ROCKY FLATS SITE

REGULATORY CONTACT RECORD 2015-04

Purpose: Mound Site Plume Treatment System (MSPTS) Reconfiguration Conceptual Approach

Figure 1

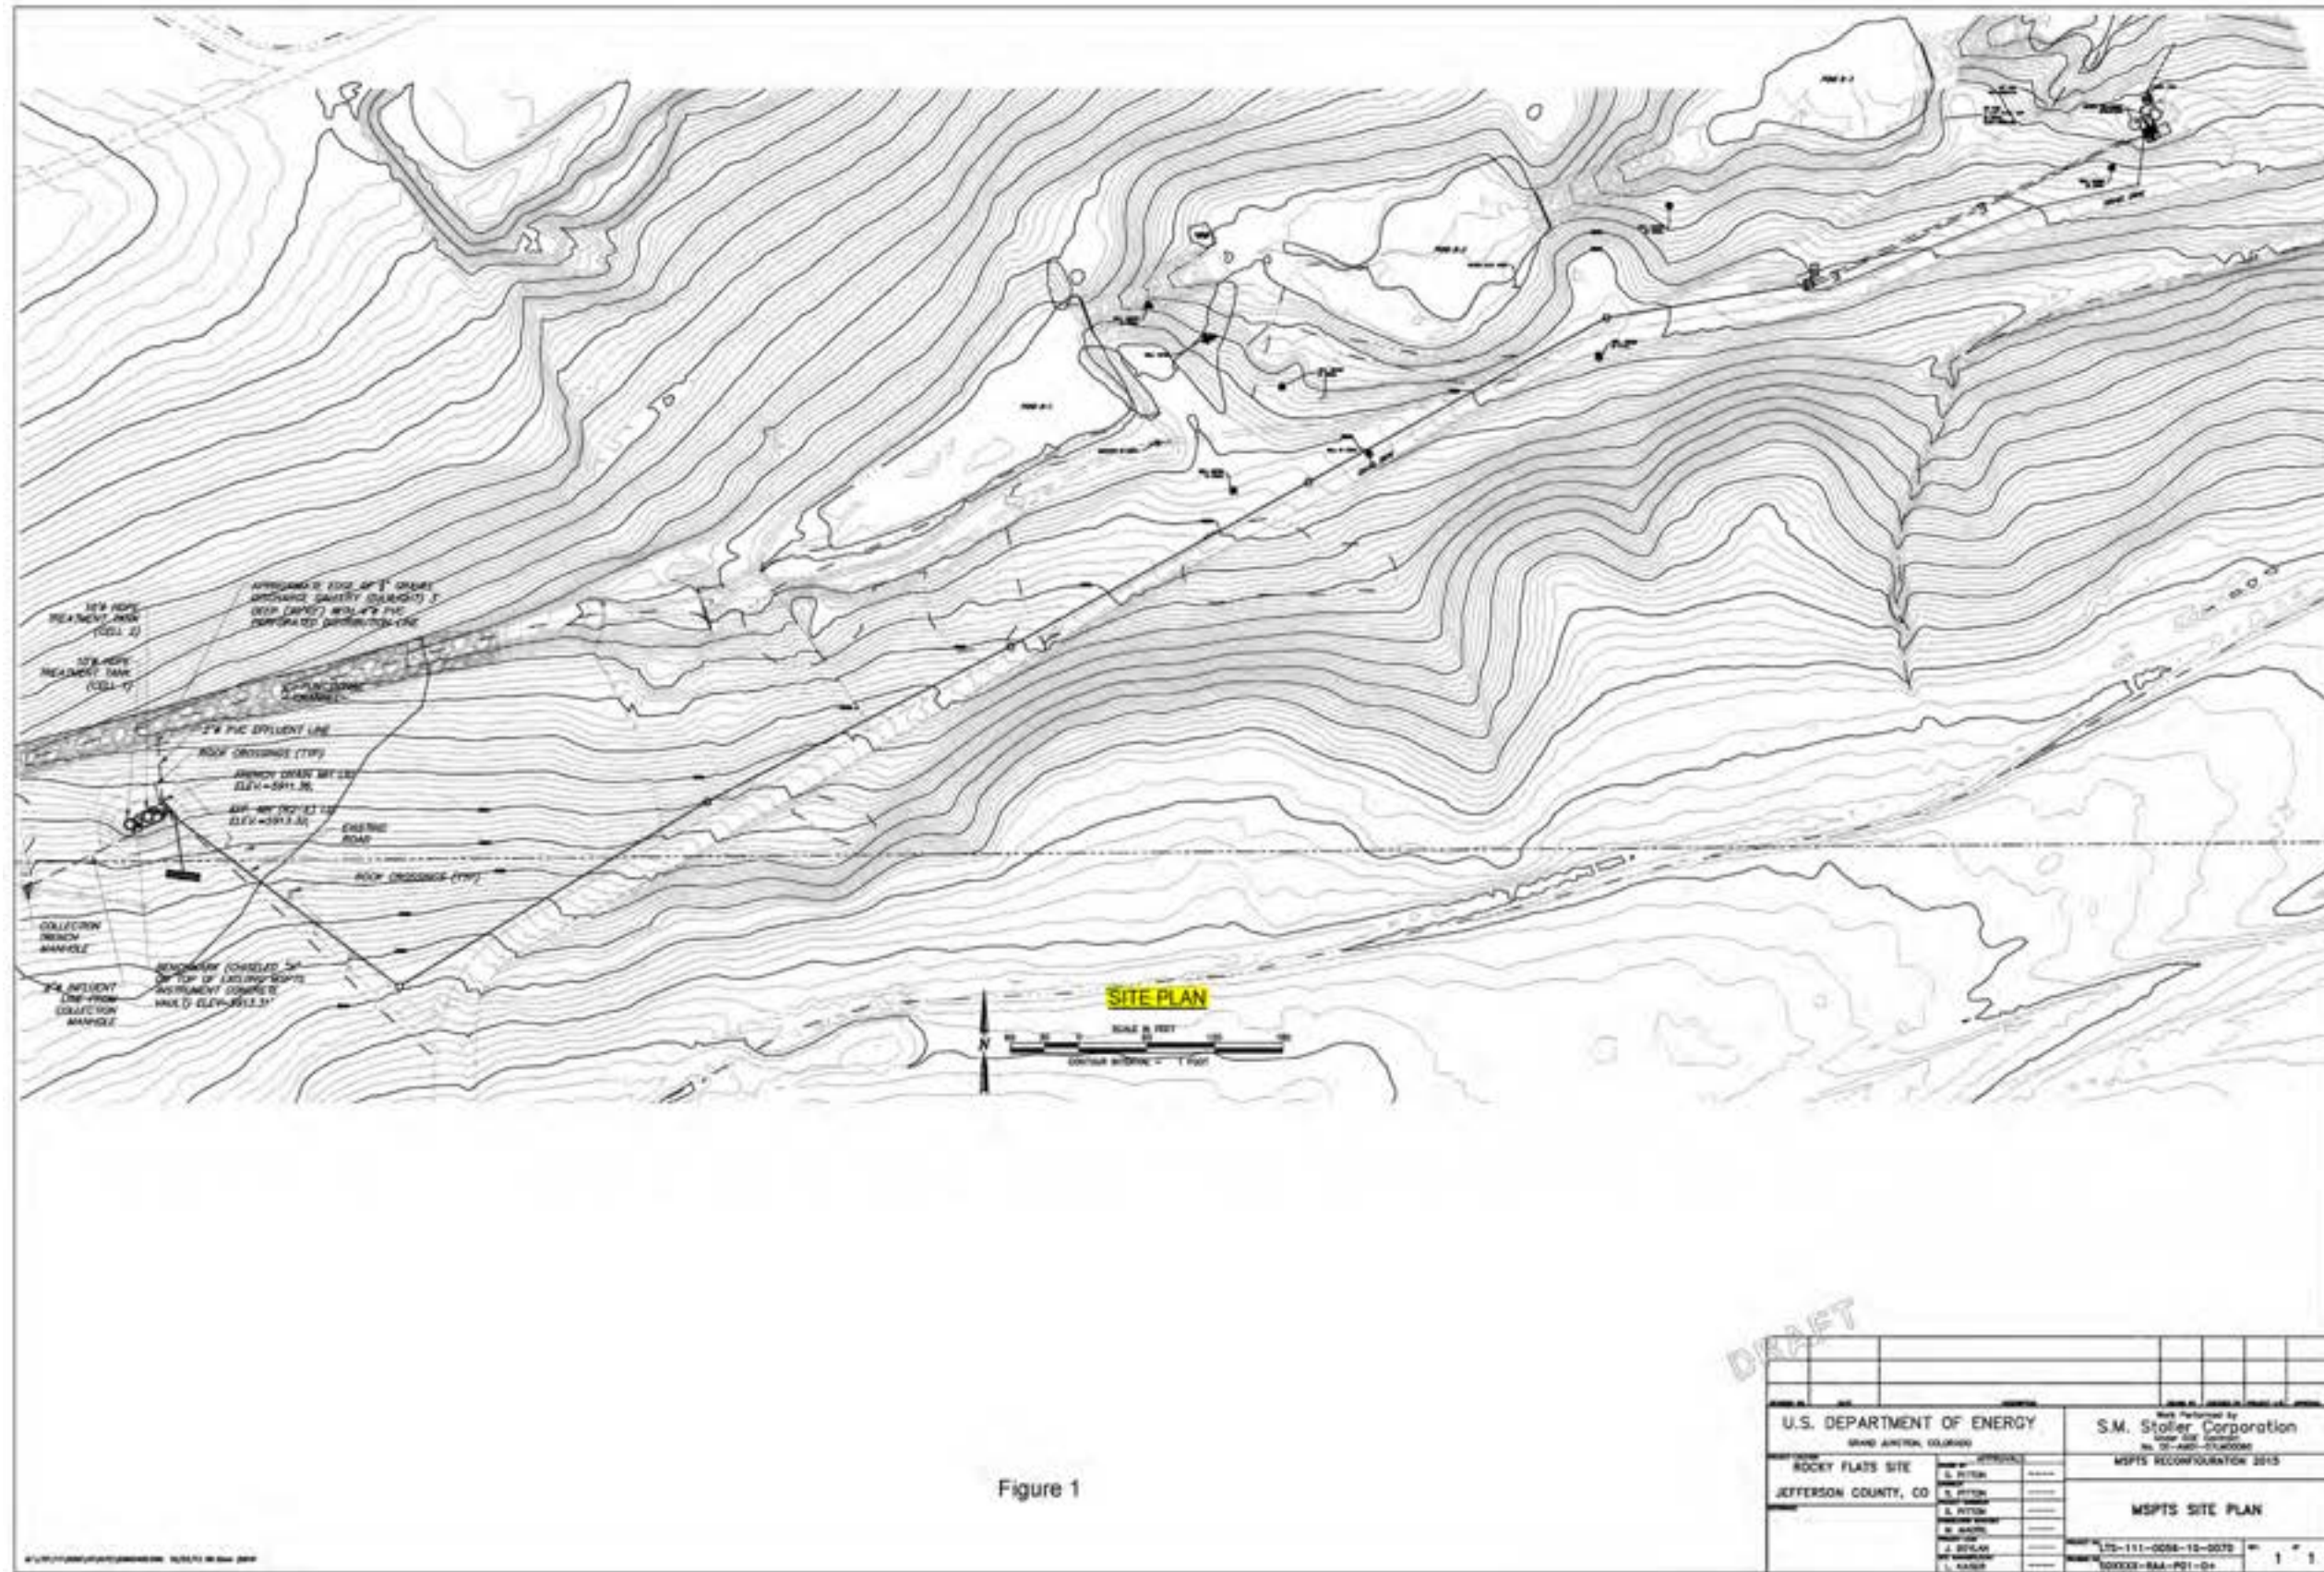
A conceptual approach has been developed and discussed among the RFLMA parties. This approach includes routing the MSPTS influent to the ETPTS air stripper; see Figure 1. The existing MSPTS tanks will initially be maintained and modified for optional water storage. The existing MSPTS effluent manhole will be replaced with a lift station and pump; water collected by the MSPTS will be pumped from this lift station to the ETPTS influent manhole. The combined MSPTS and ETPTS influents would then flow to the ETPTS influent tank and be pumped to the ETPTS air stripper in batches, just as is currently done with ETPTS influent alone. Additional solar power, piping, valves, instrumentation, and other necessary components would be installed to support this approach. Minor modifications to RFLMA Attachment 2 to reflect changes in MSPTS effluent and performance sampling locations have also been identified.

Resolution: It was agreed that DOE will prepare engineering designs for treating the MSPTS influent using the ETPTS air stripper. The RFLMA parties will consult in a timely manner on proceeding with the MSPTS reconfiguration to allow further planning and implementation as part of the MSPTS ZVI media removal project. Approval of the reconfiguration and of any required Soil Disturbance Review Plan for the work will be documented in a subsequent contact record.

Figure 3. Planned Action Locations

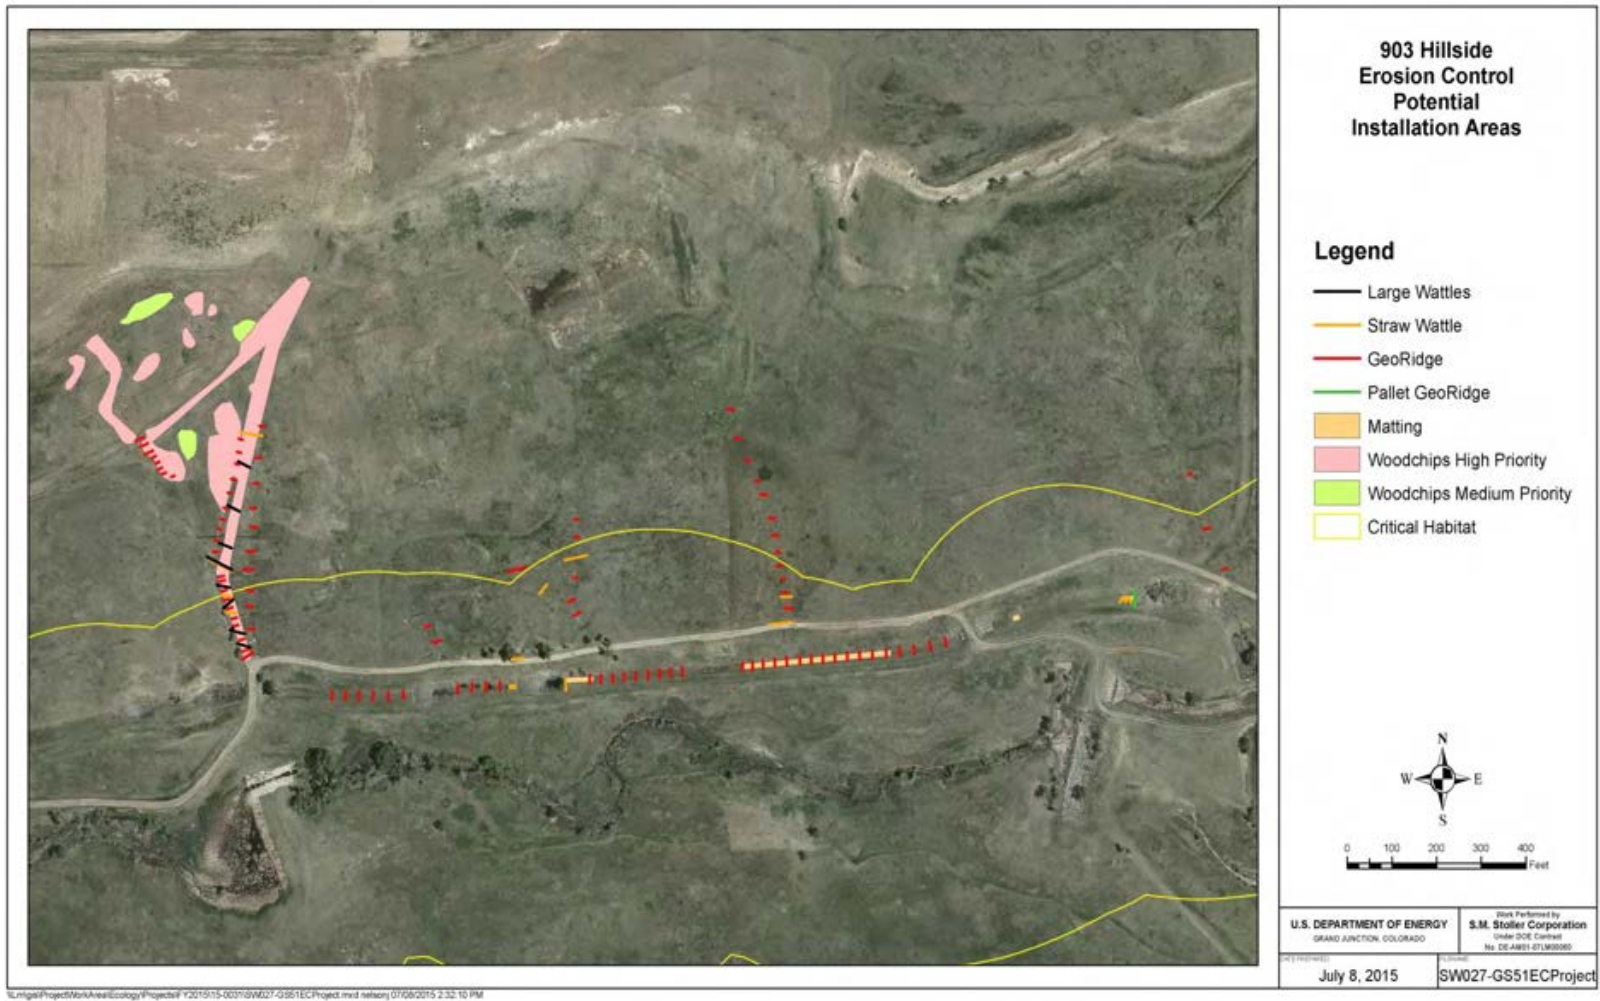
- Additional erosion control methods will be installed in the SW027 drainage, predominantly on the hillside above GS51. These measures will include matting, wattles, GeoRidge berms, and organic mulch. Several areas in the SID will also receive erosion matting; other longer-term actions for the SID are dependent on recommendations from the geotechnical engineer. Figure 3 shows the planned locations for these measures; final locations will be documented after installation. This work is scheduled to be completed by August 2015.

- On June 29, 2015, geotechnical engineers, CDPHE, and Rocky Flats personnel walked down the SID to evaluate potential use of water and sediment management devices or structures. The geotechnical engineers will provide recommendations for water and sediment management in the SID. These recommendations will be implemented in the longer term as appropriate.

Resolution: Carl Spreng, CDPHE, will review the above plan and schedule to address this reportable condition and, after consulting with EPA, may approve, approve with modifications, or disapprove this Contact Record.

PLAN VIEW

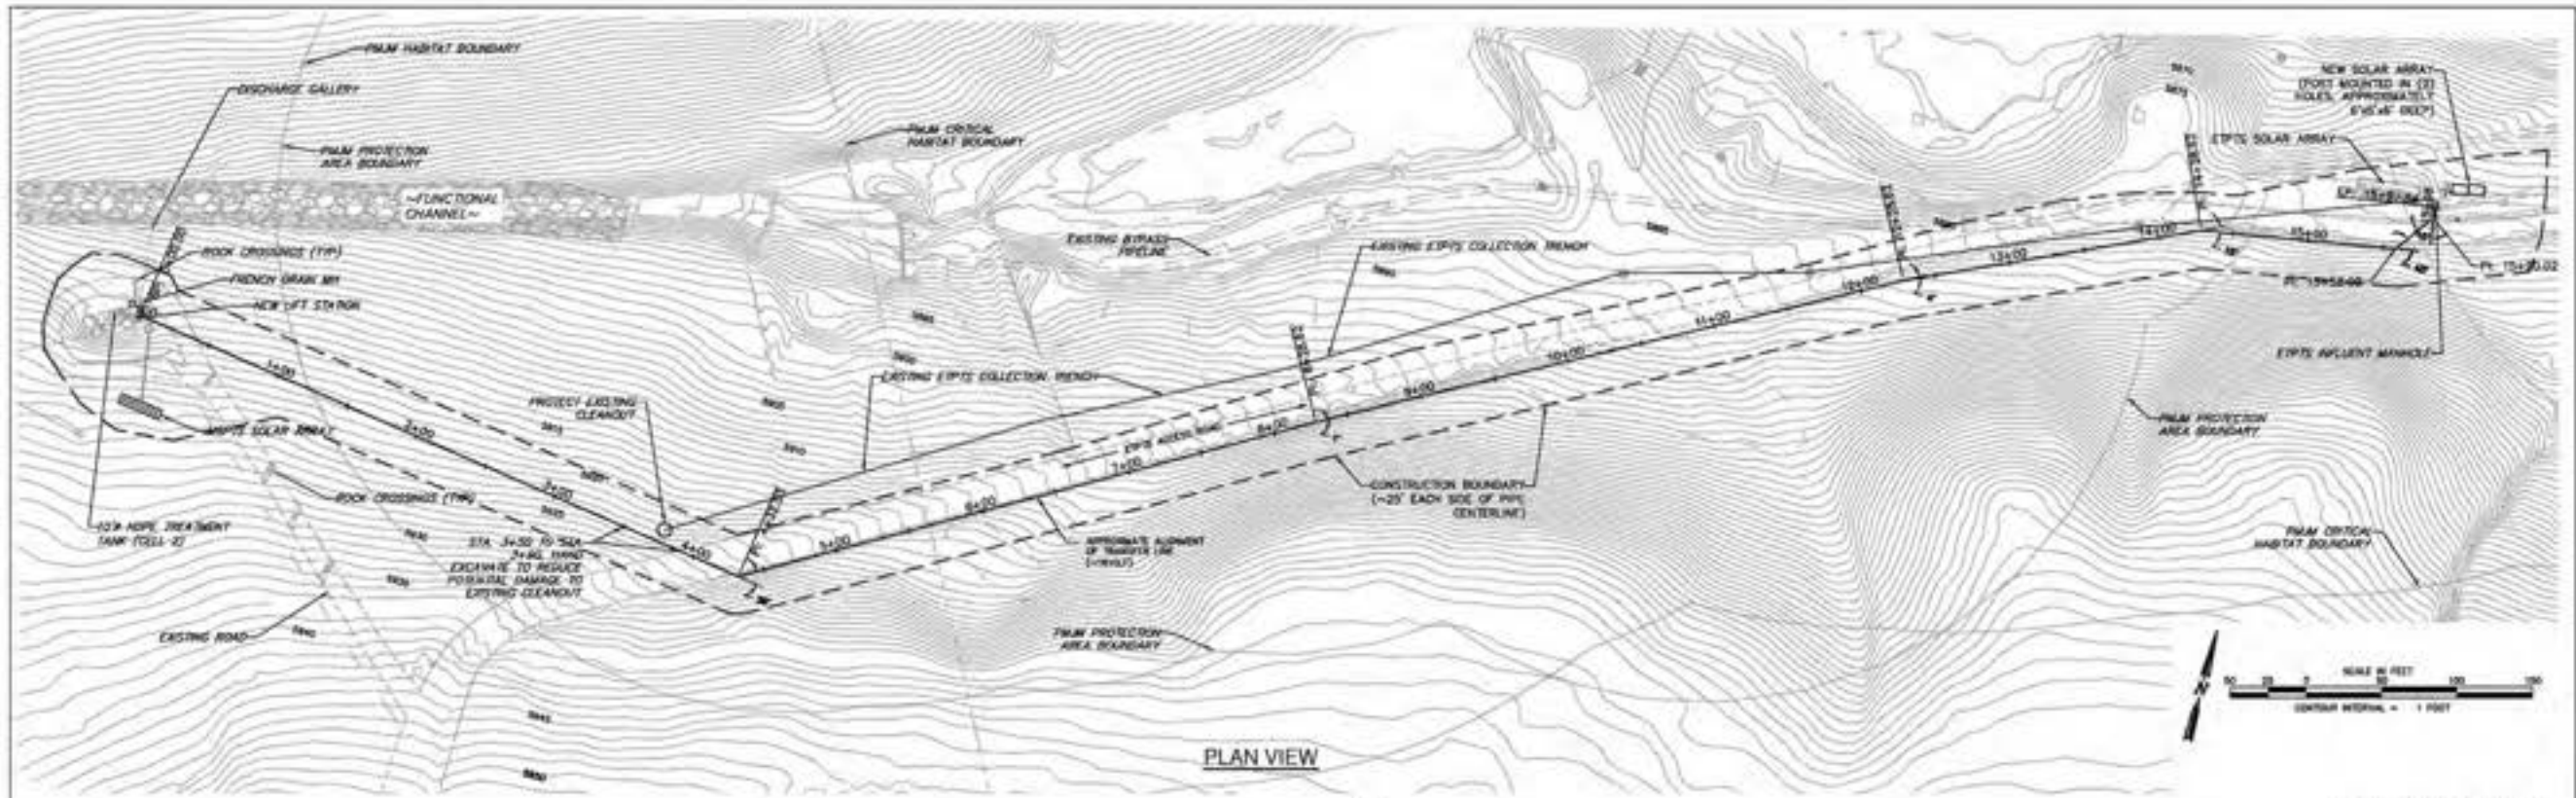
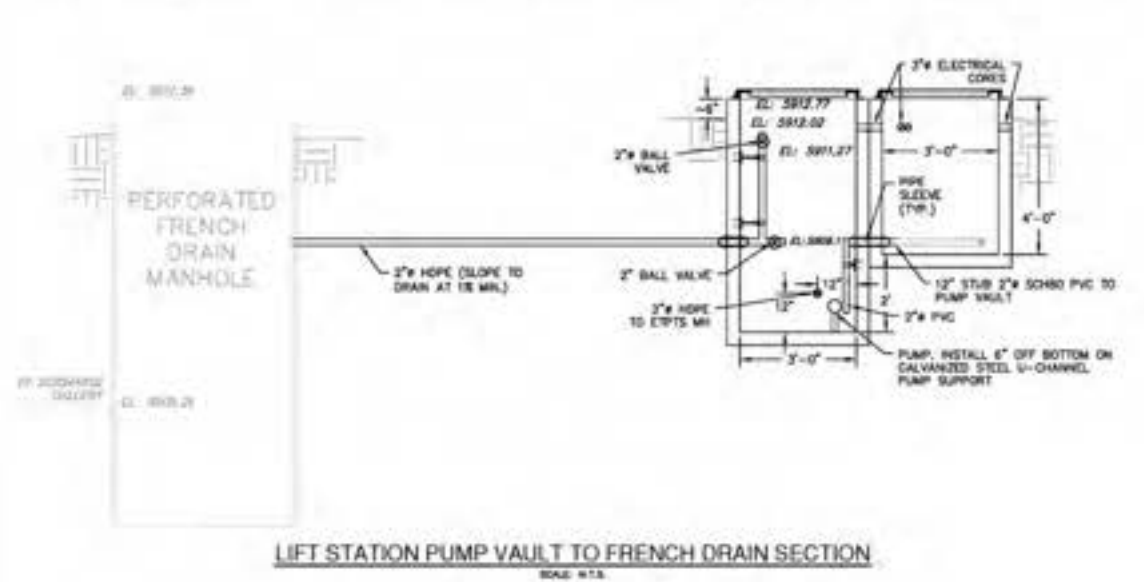
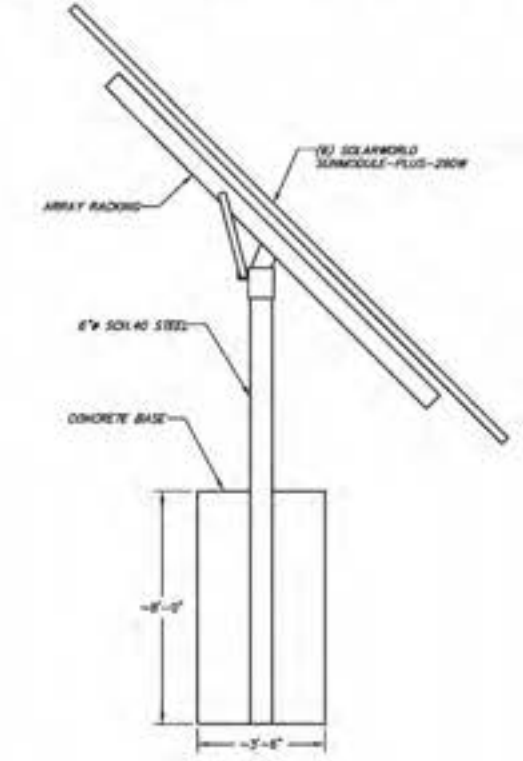
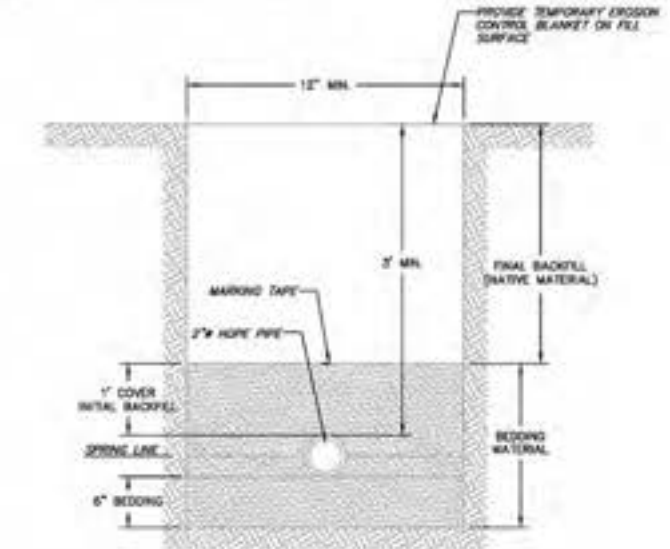
The design of the infrastructure required to implement the MSPTS reconfiguration project is complete. The design routes the collected groundwater at the MSPTS to the ETPTS influent manhole (see Figure 1). The existing MSPTS ZVI-filled treatment cells will be emptied and modified for optional groundwater storage. The existing MSPTS effluent manhole will be replaced with a lift station and pump. Water intercepted by the MSPTS groundwater intercept trench will flow to this new lift station, and will then be pumped in batches to the ETPTS influent manhole through an approximately 1600-foot-long transfer line. The combined MSPTS and ETPTS influents will then flow to the ETPTS Influent Tank, from which the water will be pumped (in batches) to the ETPTS air stripper for treatment (as is currently the case with ETPTS influent).

Additional solar and battery power will be added to the existing ETPTS power facility to enable the air stripper to operate for longer periods, thereby treating the greater volume of water represented by the combined ETPTS and MSPTS influents. The additional batteries will be installed within the existing conex, which houses the existing batteries and acts as the platform for the main solar panel array. The additional solar resources will include two pole-mounted solar panel arrays. Each of these pole-mounted arrays will require a concrete foundation (see Figure 1) set in an excavation that will be approximately 4 feet by 4 feet and 9 feet deep. Piping, valves, instrumentation, and other necessary components will be installed at the existing MSPTS. These components will require an excavation approximately 6 to 10 feet deep, 10 feet wide, and 20 feet long. The MSPTS lift station installation will require an excavation approximately 10 feet by 10 feet and 10 feet deep. The existing MSPTS solar array will not be disturbed; however, the battery box and associated concrete pad will be removed (to make way for the planned excavations and other work) and replaced with new components. All of these excavations are in pre-disturbed areas.

Resolution: CDPHE has reviewed information regarding the proposed soil disturbance and excavation and, after consulting with EPA, has approved this proposed activity. CDPHE has determined that the proposed activity will not compromise or impair the function of the remedy or result in an unacceptable release or exposure to residual subsurface contamination. CDPHE has also determined that the proposed project meets the rationale and objectives of IC 2. EPA has determined the modified remedy continues to satisfy the requirements of CERCLA Section 121.
